Please accept the responses below to your letter dated February 18<sup>th</sup>, 2026 regarding the comments for HONC 41 MPD (DCI2025-00007).

17701 N. TAMAMI  
HONC 41 MPD  
NORTH FORT MYERS

MASTER  
CONCEPT PLAN

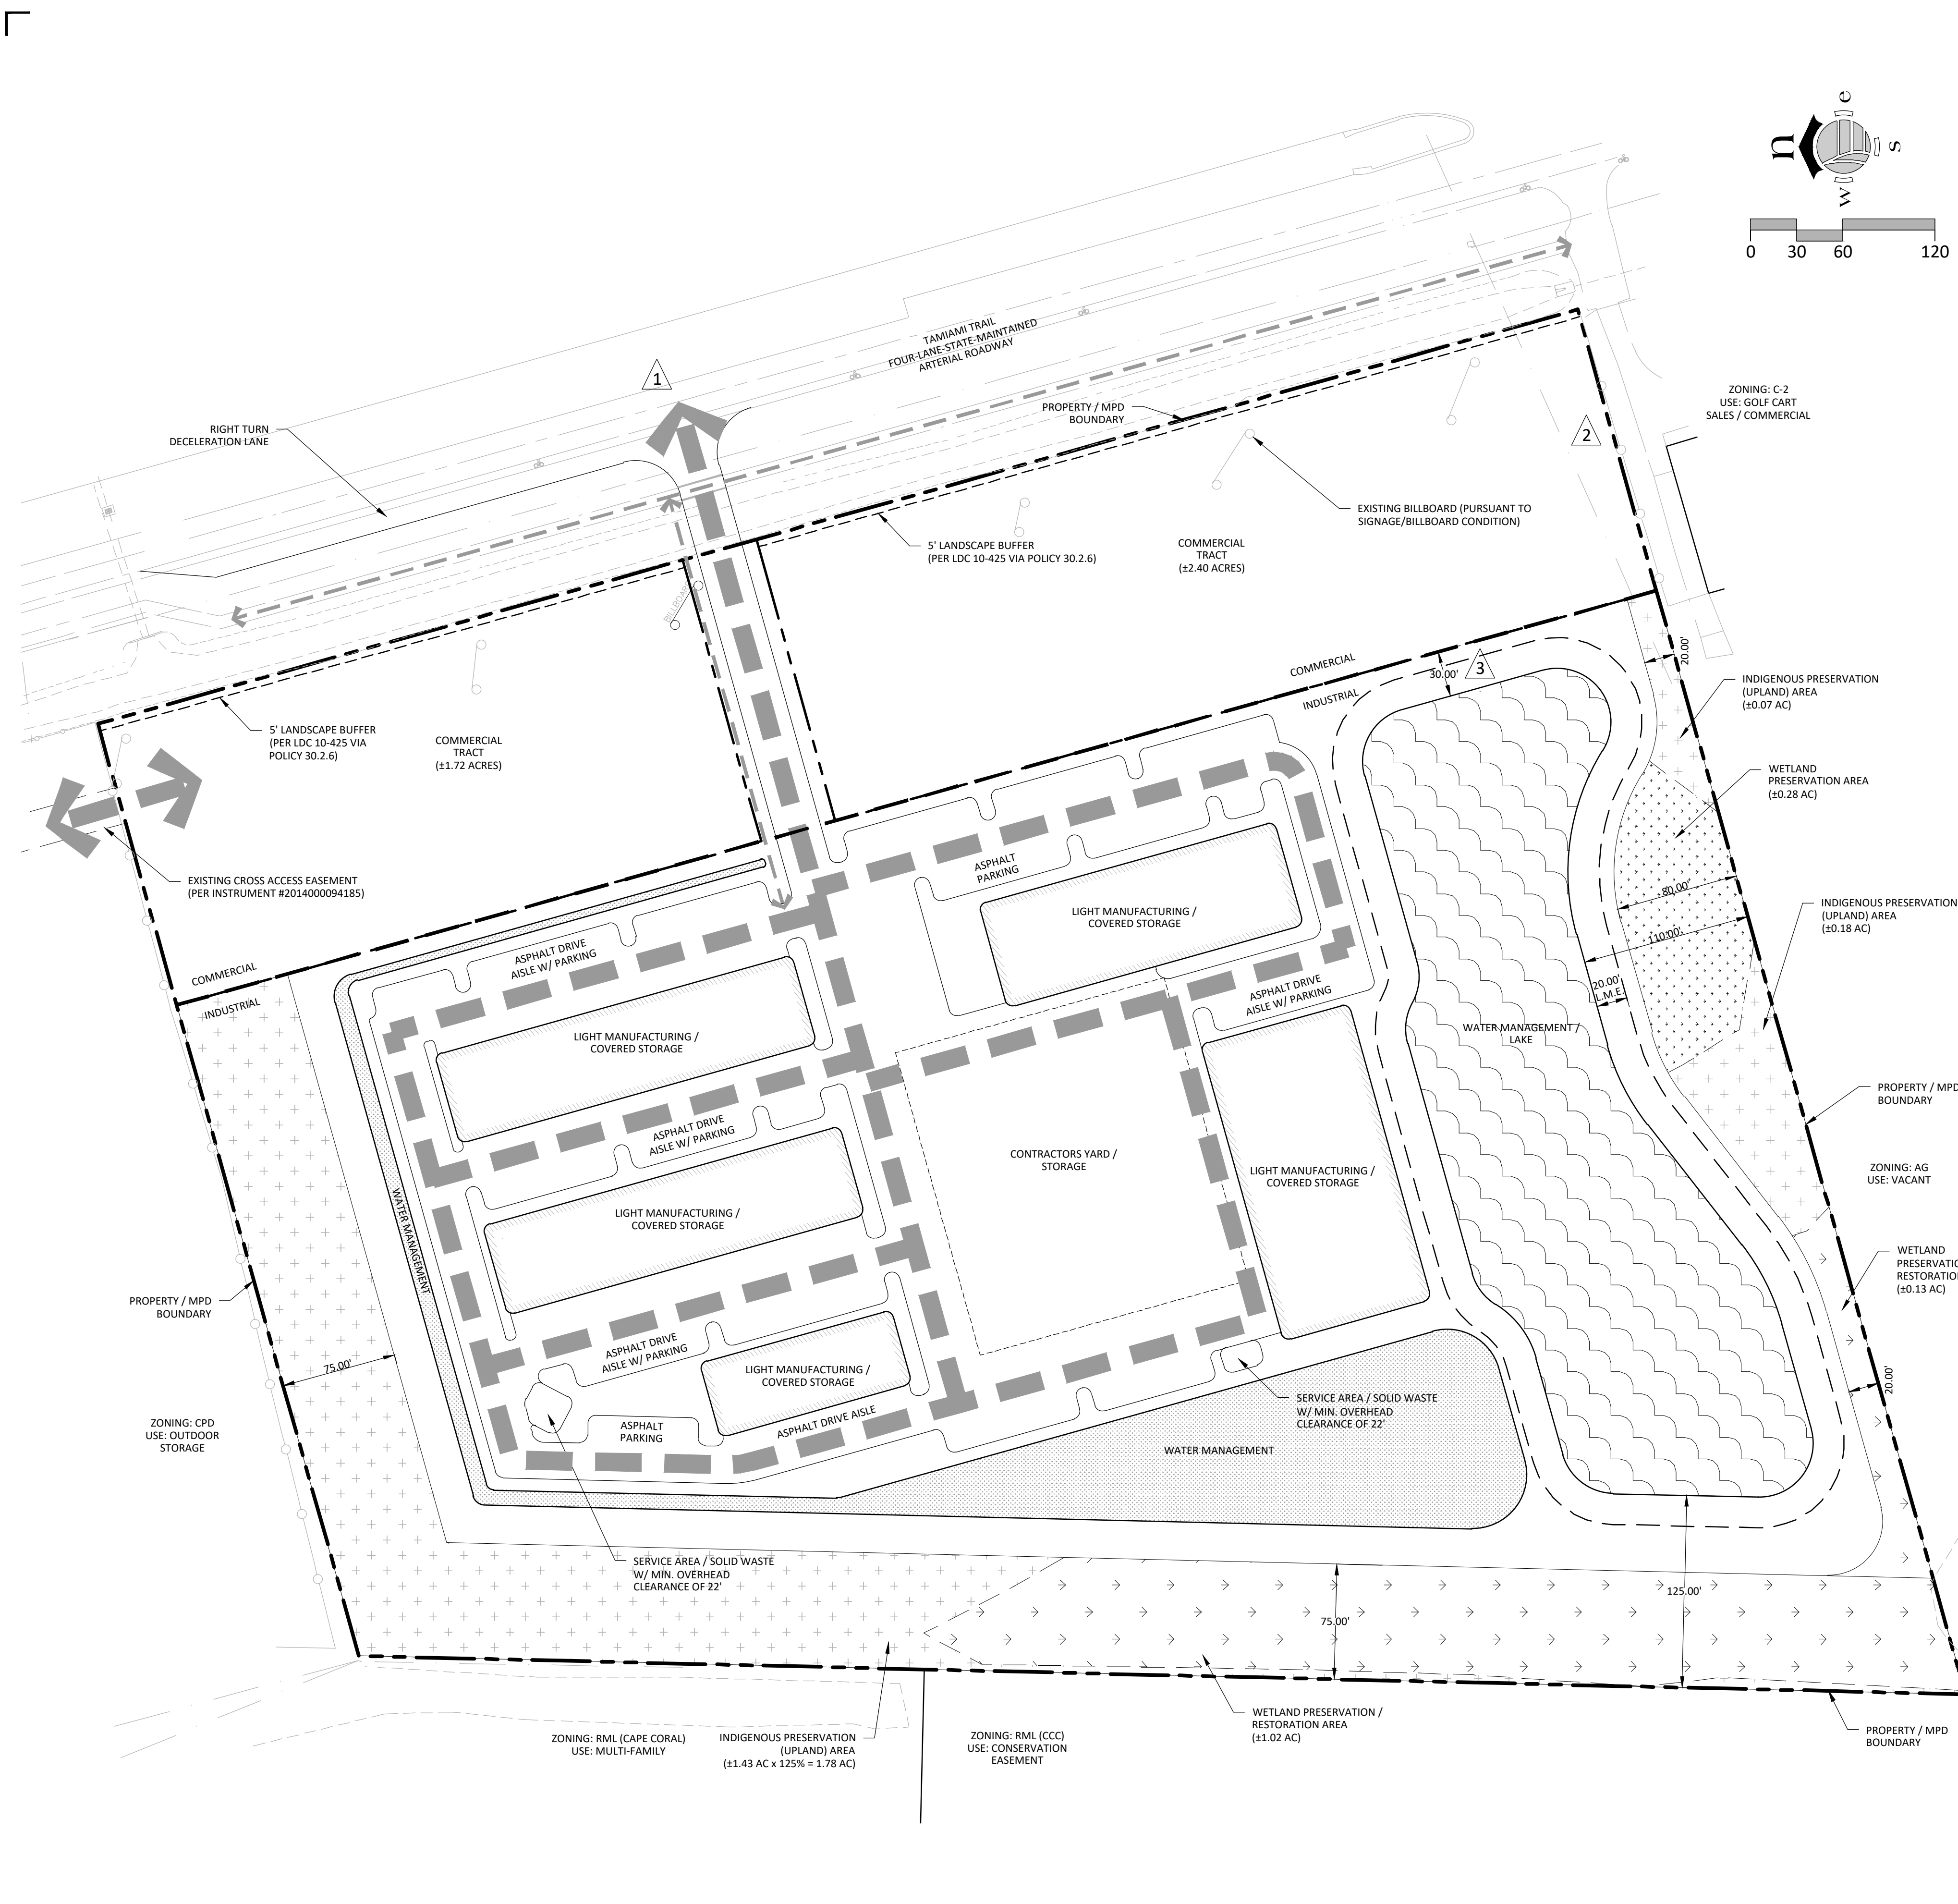
2. LDC Section 33-1572 is in Subdivision II of Commercial Corridor land development provisions, therefore, properties in the commercial corridor are required to provide publicly accessible open space.

3. Please revise Deviation 4 to state the correct LDC Section (10-425(f)) and buffer types where abutting residentially zoned districts.

4. If the preservation area is going to be utilized for the required buffer, please provide a new

deviation.

**RESPONSE: Please see the attached revised MCP, which shows the area of designated public open space.**

**RESPONSE: Deviation 4 has been removed, please see revised MCP. No buffer is required between industrial and multi-family per LDC Sec. 10-425(f)(3).**

**RESPONSE: Per LDC Sec. 10-425(f)(3) there is no required buffer along the western property line. Therefore, no deviation is required, and it has been removed per the attached revised MCP.**
